Permitting decisions

Bespoke permit

We have decided to grant the permit for Viridis 178 Red Scar operated by Viridis 178 Limited.

The permit number is EPR-WP3633DL

Figure 4.4 Costs and Benefits of Installation SCR on the Spark Ignition Engines operating for 2,000 hours per year

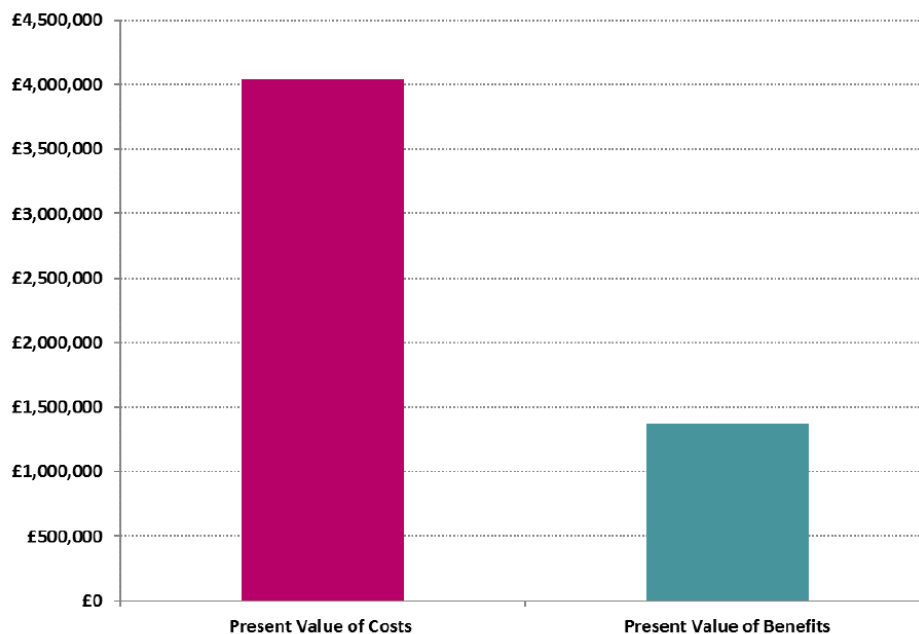
The operator provided a BAT assessment for using SCR to abate emissions on NOx. The assessment showed that the cost of SCR would have a CAPEX of £1,013,175 and an annual operating cost of £178,000 with a reduction in NOx of 51 tonnes per year. Damage costs were calculated and presented in the table below. Based on the figures the operator stated that the costs are considered to be disproportionate and the installation of SCR for small potential reduction in NOx emissions, is not considered BAT. We agree with the operator's assessment that the costs of SCR are disproportionate to the benefits.

The document 'Developing Best Available Techniques for Combustion Plants Operating in the Balancing Market' states that SCR is not BAT for plants operating for <1500 hours. BAT is stated to be enhanced lean burn engines capable of achieving 95 mg/m³ (15% O₂) of NOx.

We are satisfied the spark ignition engines exceed the minimum efficiency for electrical generation and the NOx emissions will achieve less than 95 mg/m³ and comply with the Medium Combustion Plant Directive.
